# Access Compliance Report

## Public Rights-of-Way

Intersection ID: 18244	Main Street: CROSBY_RD	Cross Street: S_SHARON_AMITY_RD	Location: SE
ADA ID: C15BA1D976AA	Ramp Type: PerpDiag	Initial Pass/Fail: Fail	Overall Compliance: No
Severity Score: 18.75			
Codes/Mitigation Info/Possible Solution		Field Measurements/Component Compliance

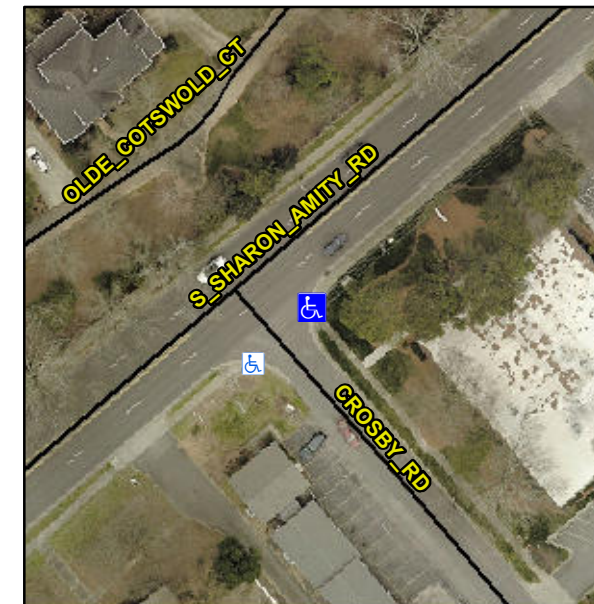
**R304.5.1, R304.5.3**

Compliance	Description	Data	Compliance	Description	Data
N/A	Ramp Length (in)	64.0	Yes	Ramp Slope (%)	6.6
No	Ramp Width (in)	34.0	No	Ramp XSlope (%)	3.1
N/A	Flare Type LT	N/A	N/A	Flare Type RT	N/A
N/A	Flare Slope LT (%)	N/A	N/A	Flare Slope RT (%)	N/A
N/A	Flare Traversable LT?	N/A	N/A	Flare Traversable RT?	N/A
N/A	Landing Length (in)	N/A	N/A	DWS Provided?	N/A
N/A	Landing Width (in)	N/A	N/A	DWS Contrast?	N/A
N/A	Landing Slope (%)	N/A	N/A	DWS Length (in)	N/A
N/A	Landing X Slope (%)	N/A	N/A	DWS Full Width?	N/A
N/A	Landing Curb? (Y/N)	N/A	N/A	DWS Offset (in)	N/A
N/A	Shared Landing?	N/A			
N/A	Gutter Ponding?	N/A	N/A	Gutter Slope (%)	N/A
N/A	Gutter Lip Ht (in)	N/A	N/A	Gutter X Slope (%)	N/A
N/A	Painted X Walk1?	No	N/A	Painted X Walk2?	No
	X Walk 1 Direction	To NW		X Walk 2 Direction	To SW
N/A	X Walk 1 Width (in)	N/A	N/A	X Walk 2 Width (in)	N/A
	X Walk 1 Slope (%)	4.4		X Walk 2 Slope (%)	3.7
	X Walk 1 X Slope (%)	1.2		X Walk 2 X Slope (%)	3.9

**Remove & Replace Curb Ramp With Two New Directional Ramps or Equivalent.**
